THE COLONG FOUNDATION FOR WILDERNESS LTD.

Tuesday November 5th, 2019

Snowy 2.0 Main Civil and Hydro-electrical Engineering Works
NSW Department of Planning and Environment
GPO Box 39
Sydney NSW 2001

Submission as an Objection to the Main Works for Snowy 2.0 as outlined in the Environmental Impact Statement (EIS) of September 2019 - SSI-9687

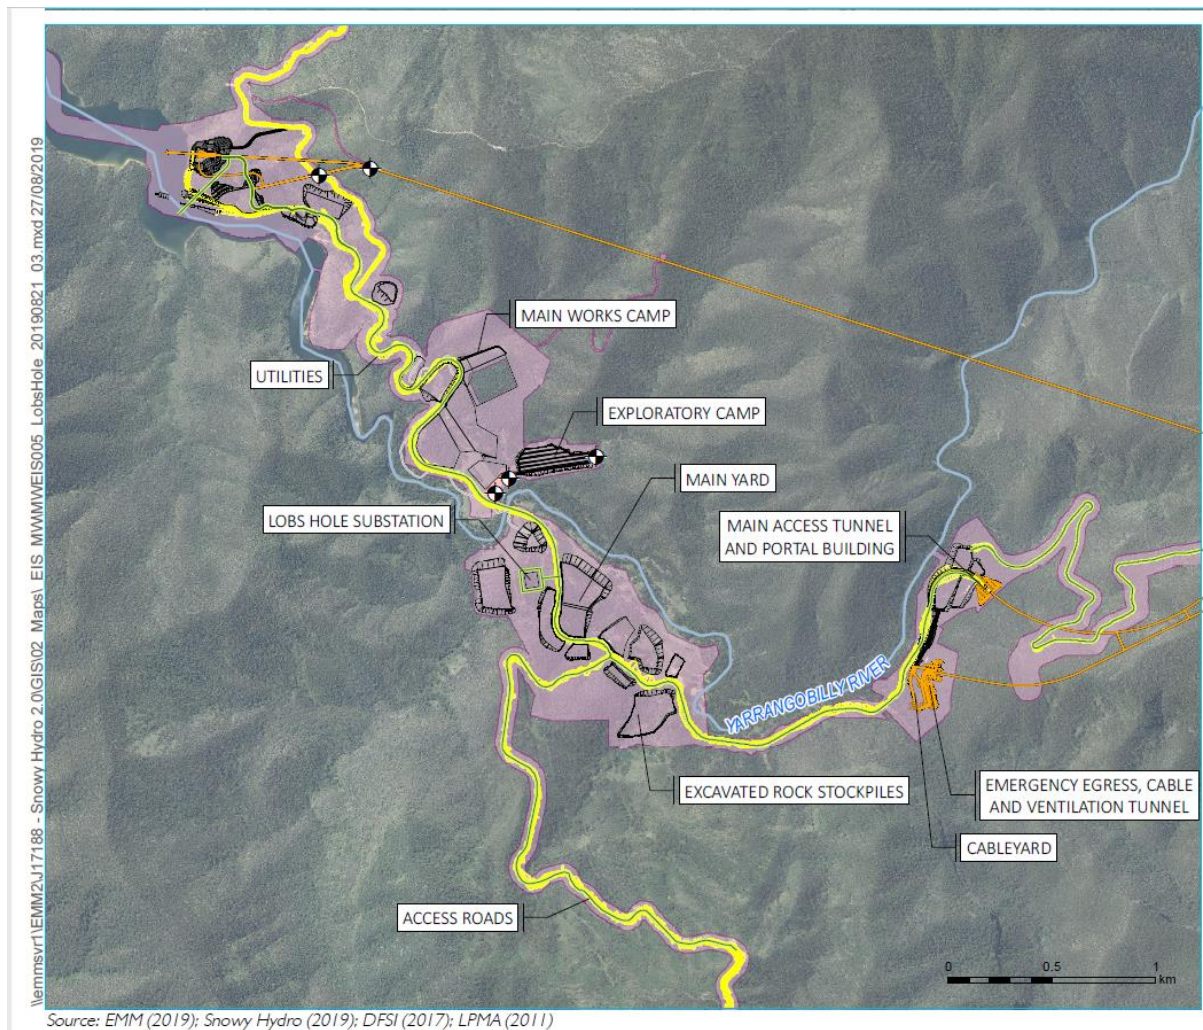
The exploratory stage of the project has already been approved to dump 750,000m³ of rock, some of which is acid forming, some 50 metres from Booroolong Frog (*Litoria booroolongensis*) habitat in the Yarrangobilly River. This frog is a nationally listed endangered animal and recorded 56 times in streams that will be seriously impacted by the approved exploratory development. However, these 'exploration' works that will bulldoze 95 hectares of Kosciuszko National Park for a 4.4 kilometre reach of the Yarrangobilly River, pale to a lesser impact compared with the current scale of proposed works for this stage of the project. It will dump a further 5,250,000m³ of rock waste, mostly beside this river, as well as on the Marica plateau and beside the Tantangara reservoir. The chances of this population surviving are low (see page 10 of this submission for an image of this frog). Yet these dumps are a minor fraction of the rock waste, and a further 8,000,000m³ will be dumped in the storage of Talbingo and Tantangara Reservoirs.

Visual scarring will be produced by million tonnes of rock waste proposed to be dumped in large piles at Lobs Hole, Tantangara and Marica. Add the scarring of the national park from the greater variability of water levels in Tantangara Dam. The loss of groundwater along the length of the tunnel will expand environmental losses, including the alteration of the Eucumbene River headwaters to an ephemeral stream, which will cause a significant loss of aquatic life. The significant linear impacts of the scheme appear to have been brushed aside, rather than minimised through active consideration of alternative engineering options.

EIS Figure – illustration 1 showing the extent of proposed dumping along the Yarrangobilly River (a large proportion of the 6,000,000m³ dumped on Park in addition to that dumped in reservoirs), and clearing caused by the proposal, including for a new road into the river valley from the Marica plateau.

EIS Figure - illustration 2 – showing the extent of roading, facilities, clearing and dumping of road construction materials in the old growth forests of the Marica plateau.

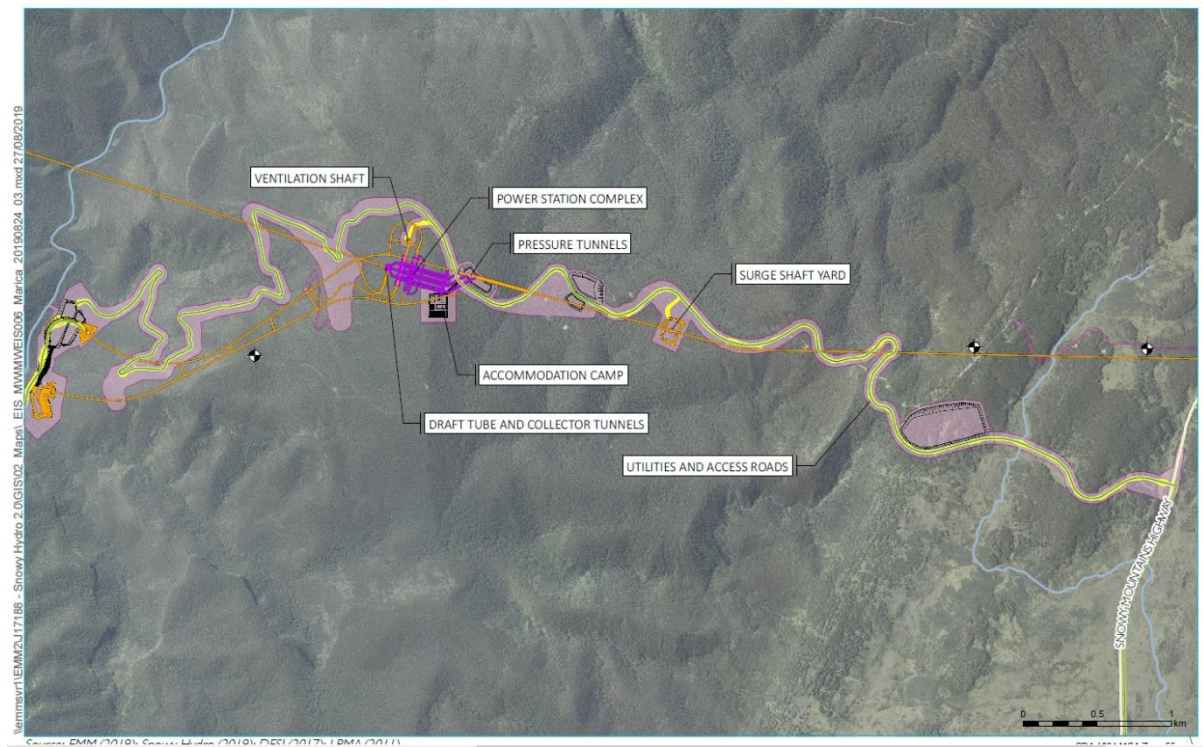
Significant adverse impacts include: a new road through old growth forests and woodlands at Marica down an escarpment to Lobs Hole; the dispersal of a pest species from the Murray into the Murrumbidgee River system; and millions of tonnes of hard rock dumped on the national park.
